From: Zan <olivethesprite@gmail.com>
Sent: Tuesday, February 2, 2021 5:28 PM
To: Hildy Stern; Steve Napolitano; Richard Montgomery; Joe Franklin; Suzanne Hadley
Cc: City Clerk
Subject: [EXTERNAL] 2.2 Council Letter re: hotel 4 attachments
Attachments: AIR SUN PRIVACY suzanne best.pdf; ATT00001.txt; TRAFFIC suzanne best.pdf; ATT00002.txt; PARKING suzanne best.pdf; ATT00003.txt; NOISE suzanne best.pdf

Good evening Mayor and City Council,

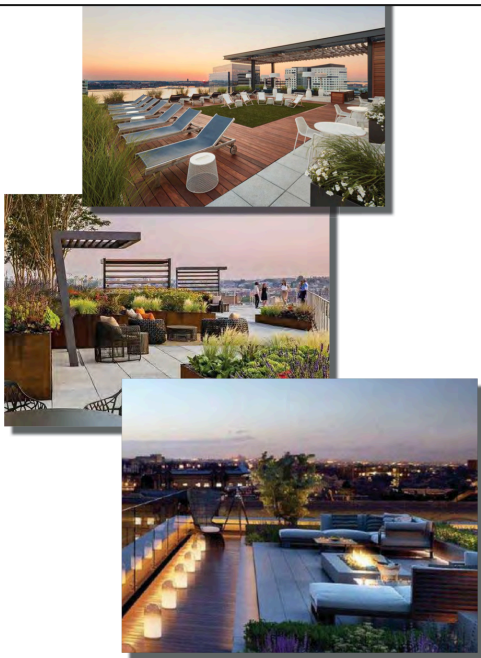
Anyone that has given the staff report a cursory review is aware that this project plans a rooftop bar. At last Tuesday's council meeting, the applicant stated twice there was no rooftop bar. Following are a snippet of the audio recording, and the related transcript. Following that, are instances within the staff report which state that there is in fact a rooftop bar.

ROOF LEVEL LANDSCAPE PLAN
 MANHATTAN BEACH HOTEL
 CONCEPT / SCHEMATIC LANDSCAPE PLANS

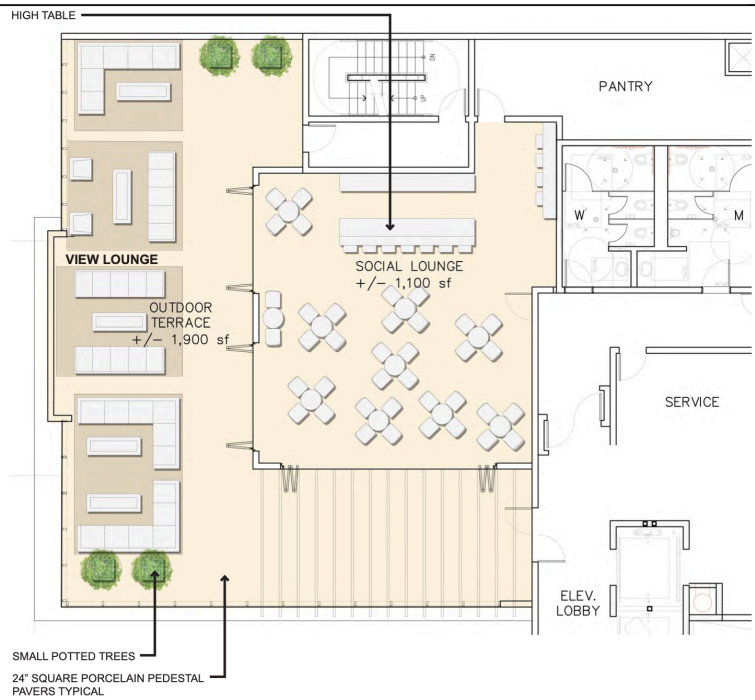
The roof level landscape plan, below, clearly shows the rooftop bar has a footprint of 3000 sq.ft., with seating depicted for 80. This space is significantly larger than most homes in the neighborhood. We request an EIR or denial of the project.
